Modification Recommended Service Note

E36155A 800W Autoranging Benchtop Power Supply, 60V, 40A

Serial Numbers: MY62101001 - MY63001001

The Problem – ATTENTION – Firmware update to 1.1.14-1.0.1-1.16 and newer is mandatory for non-ATMU user only.

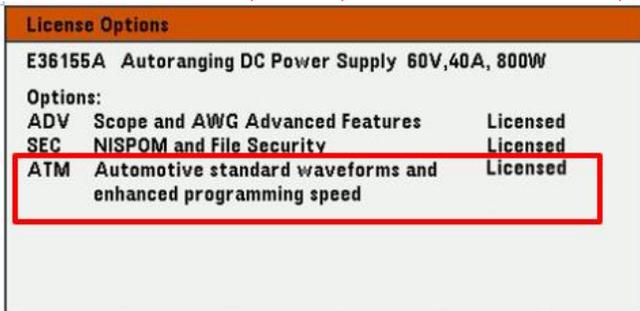
Instrument with the firmware version 1.1.10_1.0.1_1.16 and older, may encounter failure during operation.

The below errors will be shown:

- Dashes “---”
- Error 614: Invalid serial number
- Error 561: Analog board (CH1) does not respond

For **non-ATMU users**: Firmware update to 1.1.14-1.0.1-1.16 and newer is mandatory to adjust the maximum slew rate to 4000V/s (15ms) according to the data sheet specification.
